- 1. St. Theresa Subdivision Merkes Addition
KPB File 2025-003
Johnson Surveying / Ande, LLC
Location: Steadman Street & Hall Road
Sterling Area**

St. Theresa Subdivision Merkes Addition Preliminary Plat

**ITEM #1 - PRELIMINARY PLAT
St. Theresa Subdivision Merkes Addition**

KPB File No.	2025-003
Plat Committee Meeting:	January 27, 2025
Applicant / Owner:	ANDE, LLC / Soldotna, AK
Surveyor:	Jerry Johnson / Johnson Surveying
General Location:	Steadman St east of Soldotna

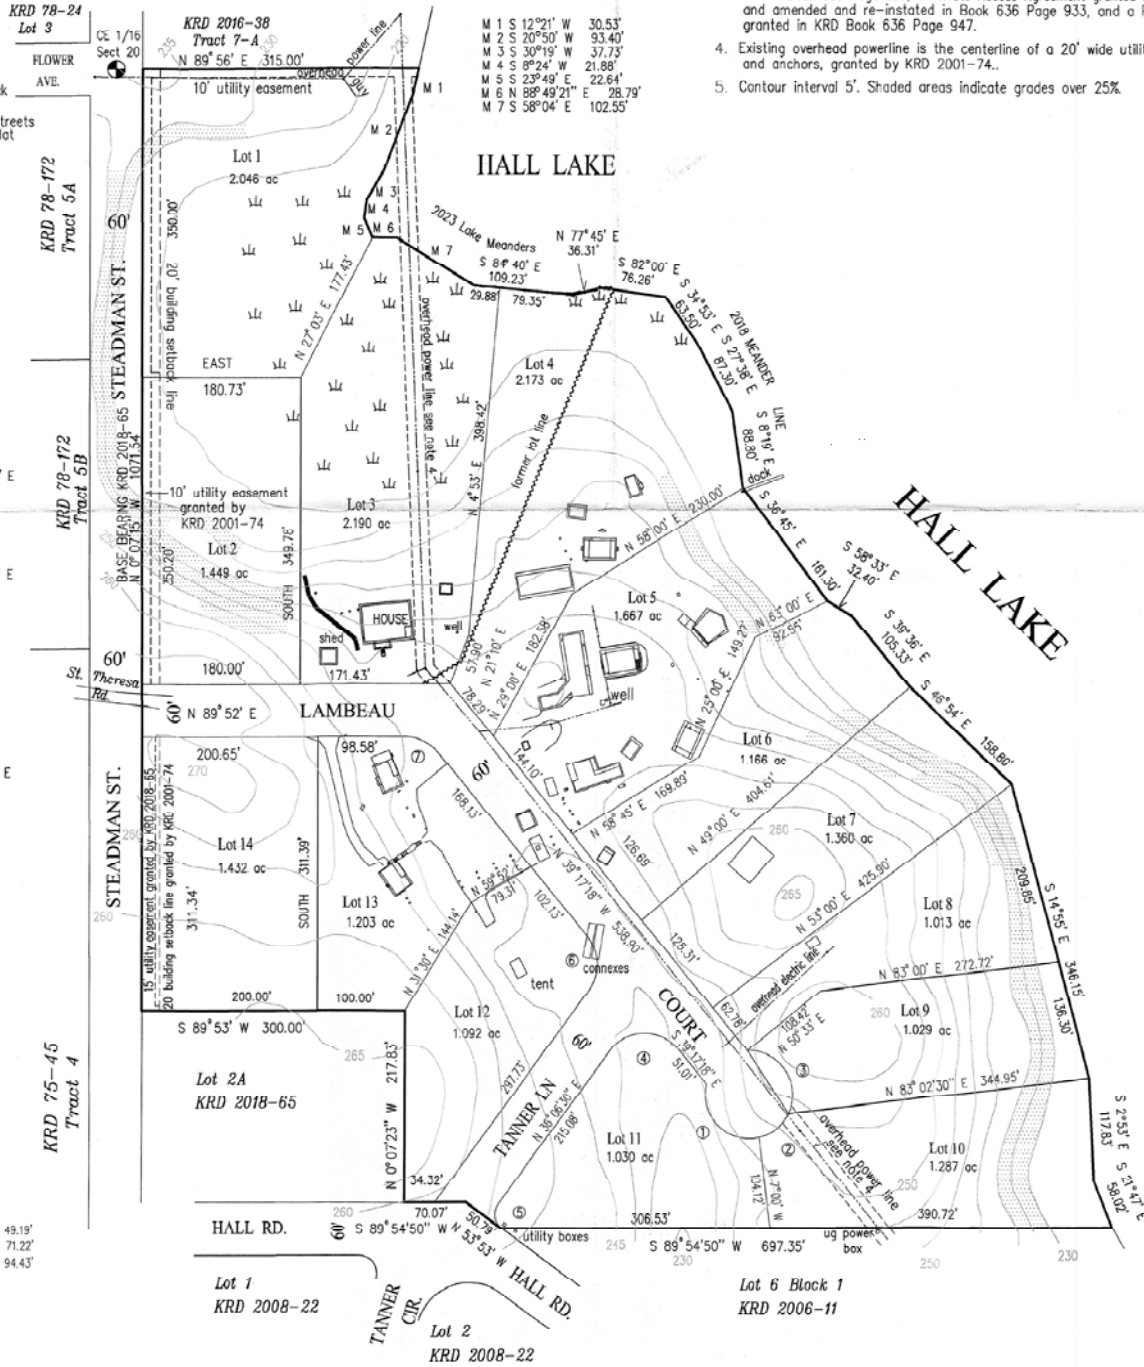
At plat note 3 are listed the Agreements and Easement for access to the property. **Staff recommends** the surveyor add reference to the plat note near St. Theresa Rd on the west side of the plat and in the plat note reference to these being located along St. Theresa Rd.

There are several structures located on the property, that when the plat is complete will be located on Lots 3, 4, 5, 7, 8, 12 and 13. Plat note 1 indicates some of the structures to be within the 20' building setback and predating it's establishment therefore not subject to it. **Staff recommends** the surveyor show the buildings in to the setback with dimensions and distances encroached for reference to the ones predating the setback creation. The plat note should be revised to state '*Several existing structures are located within the building setback and utility easement as shown, which predate the limitations creation. Any additional, new or replacement construction to the structures, will be subject to the 20' building setback and easement requirements.*'

There are structures in the shown in the right-of-way of proposed Lambeau Ct. these structures will need to be removed prior to the finalization of the plat. **Staff recommends** the surveyor to provide proof of the removal prior to Admin Approval of the Final Plat.

There are steep areas shown on the plat with shading being the indicator within the contours. Staff recommends on the final submittal the surveyor remover the contours and leave the shading, adding to the legend an icon of the shading over 20%.

There are wetlands on the plat as shown. KWF wetlands Assessment indicates more wetlands to be shown along the lake and in the southeast corner of the plat. **Staff recommends** the surveyor review the assessment and necessary labeling to the drawing. Add the note "Any person developing the property is responsible for obtaining all required local, state, and federal permits, including a U.S. Army Corps of Engineers wetland determination if applicable."

Add the right-of-way width to Tanner Cir to the south, and Flower Ave to the west.

Add the Bk and Pg of the access easement for St. Theresa Rd going west to the drawing and reference to a plat note.

Add the other access easement for St Theresa Rd, listed in the Certificate to Plat as a plat note.

Label Hall Lake

Change label for plat from 'Location' to 'Plat Location'

Per KWF Wetlands Assessment, there are areas of Lake and Riverine to be shown on the drawing

There are encroachments shown in Lambeau Ct right-of-way that need to be removed Structures locate within the 20' building setback, even though existing need dimensions documenting the distances into the setback and size of the structure.

St. Theresa Subdivision Merkes Addition Preliminary Plat

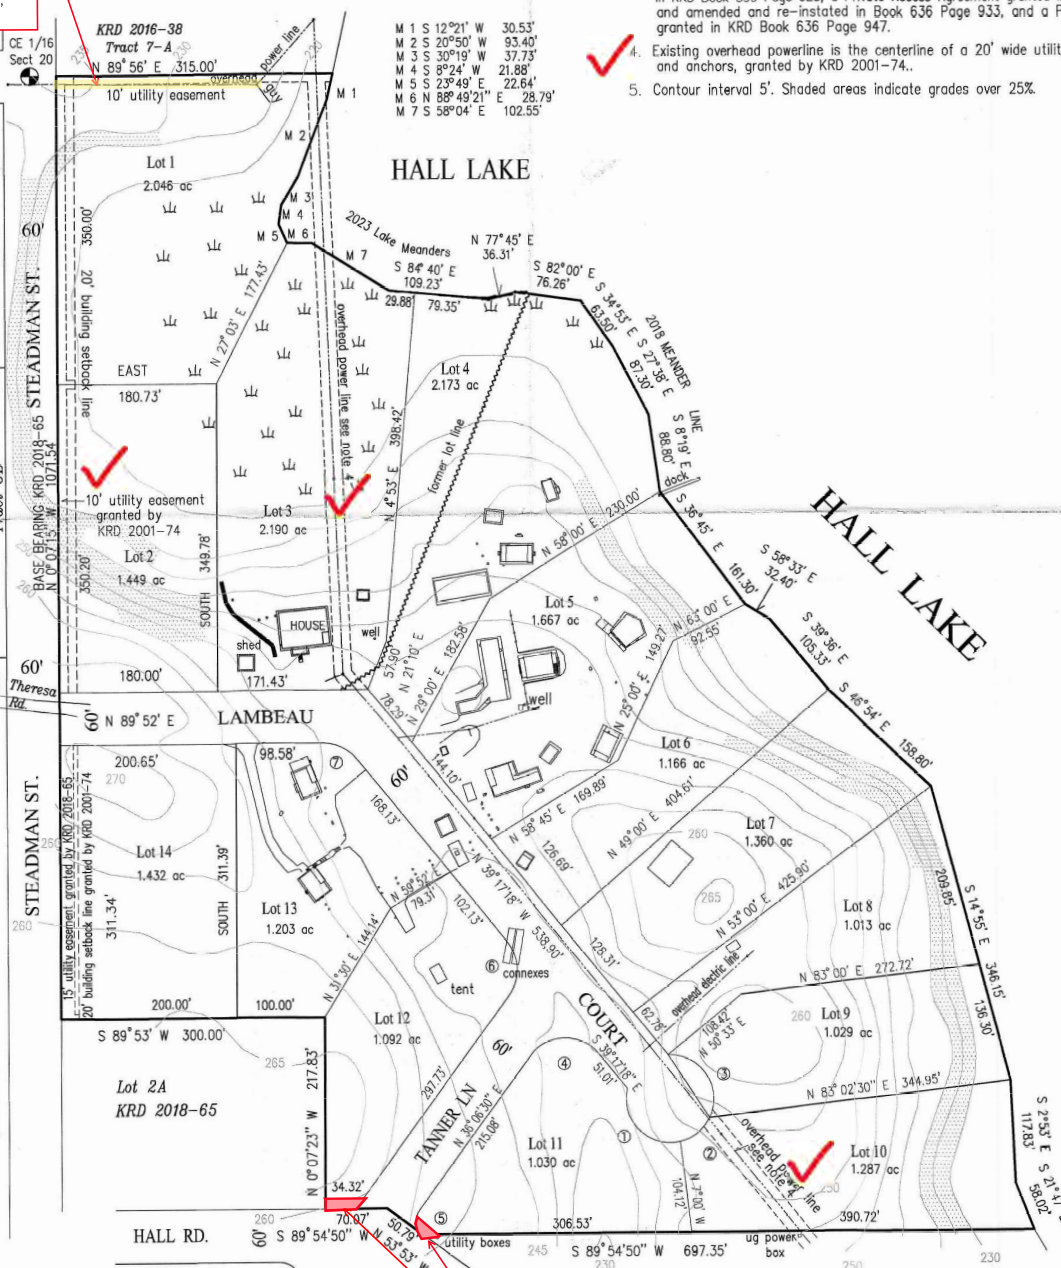
Provide a label or plat note stating, "The existing overhead powerline is the centerline of a 30-foot-wide electrical easement, including guys and anchors, granted this plat."

Depict and label the 15 foot utility easement as granted on plat 2018-65 KN.
